**SUNDRY NOTICES AND REPORTS ON WELLS**  
**Do not use this form for proposals to drill or to re-enter abandoned well. Use Form 3160-3 (APD) for such proposals.**

8. Well Name and No.  
COTTON DRAW UNIT 68

9. API Well No.  
30-015-20272

Proposed Plug & Abandonment

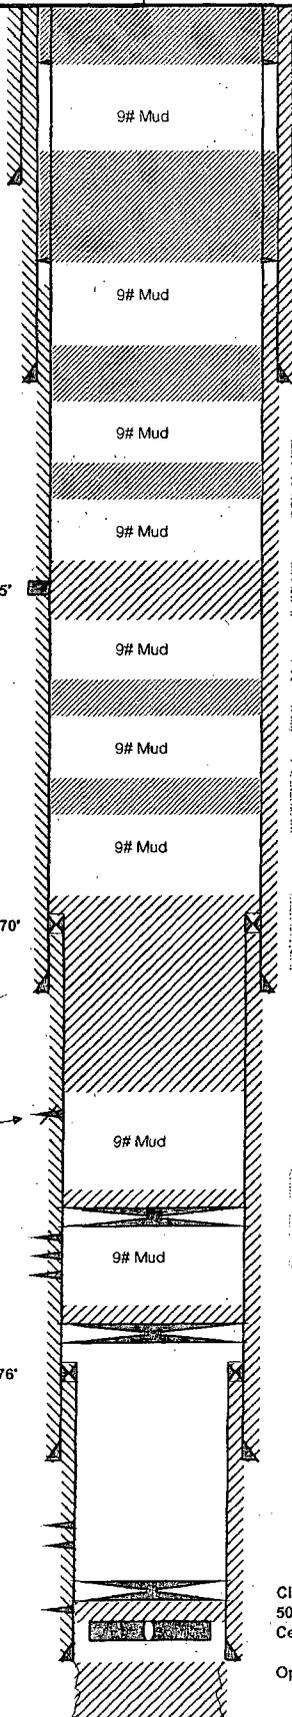
- Spot 160 sx (670') CI H from 12,220' to 12,890'. Tag TOC (7-5/8" liner top @ 12,270', 9-5/8" csg shoe @ 12,650', Wolfcamp top @ 12,890') *WOC Tag*
- Spot 40 sx (100') CI H from 10,150' to 10,250'. (Spacer plug) *200' plug 10250-10050.*

- Spot 40 sx (100') CI H from 8,215' to 8,315'. (Top of Bone Springs @ 8,315') *180' plug 8400-8220.*
- Spot 40 sx (100') CI H from 7,865' to 7,965'. (DV Tool @ 7,915') *180' plug 7800-7620. WOC Tag*

- Spot 32 sx (100') CI C from 6,150' to 6,250'. (Spacer plug) *160' plug 6300-6140*
- Spot 80 sx (265') CI C from 4,200' to 4,465'. Tag TOC. (Salt bottom @ 4,300', 13-3/8" csg shoe @ 4,415')

*Below ground level dry hole marker required* *RJD 7/21/2015*

Proposed: 160  
1. Spot 32 sx (180') CI C from 6,150 to 6,250' (Spacer Plug)

Proposed: 180  
1. Spot 40 sx (100') CI H from 7,865' to 7,965'

Proposed: 180  
1. Spot 40 sx (100') CI H from 8,215' to 8,315' (Top of Bone Spring @ 8,315')

Proposed: 200 10050  
1. Spot 40 sx (100') CI H from 10,150' to 10,250' (Spacer plug)
